UNITED STATES PATENT AND TRADEMARK OFFICE

APPLICATION NO.	FILING DATE	FIRST NAMED INVENTOR	ATTORNEY DOCKET NO.	CONFIRMATION NO.
09/862,585	05/23/2001	Terry Hermanson	1907.P124	8392

Office Action Summary

DETAILED ACTION

Examiner's illustration

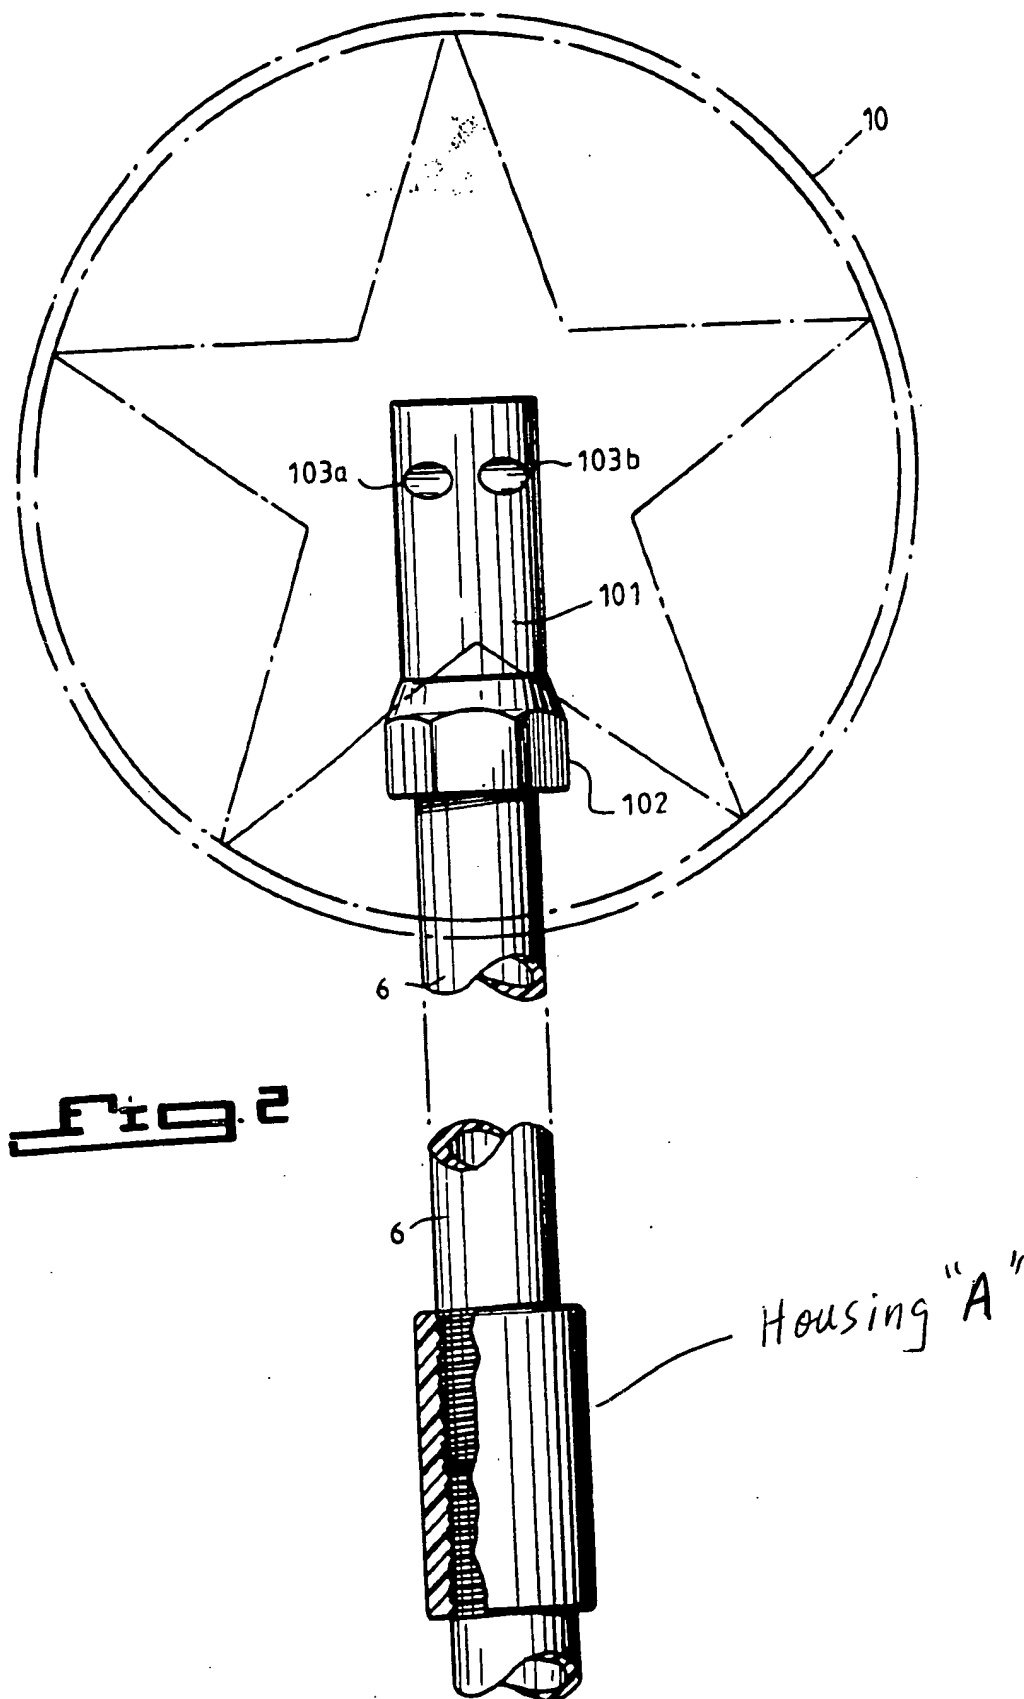
Claims 1-4 and 6-12 are rejected under 35 U.S.C. 102(b) as being anticipated by Cawley et al'586. Cawley'586 discloses a tree-top mounting device comprising a housing (the threaded connector A connecting two parts of 6, fig. 2 as shown by examiner's attached illustration), an elongated support (101 and 6) slidably received within the housing, a fitting head (101) disposed at a distal end of elongated support and a fastener (the threaded inner walls of connector A in figure 2) adapted to secure the housing to the tree; a lock to secure the sliding rod (threaded external portion of rod 6) in the housing; a fitting head includes bayonet coupling (figure 3A and figure 3B) comprising a disc (102, fig. 2) and a cylindrical connector (101, fig. 3A).
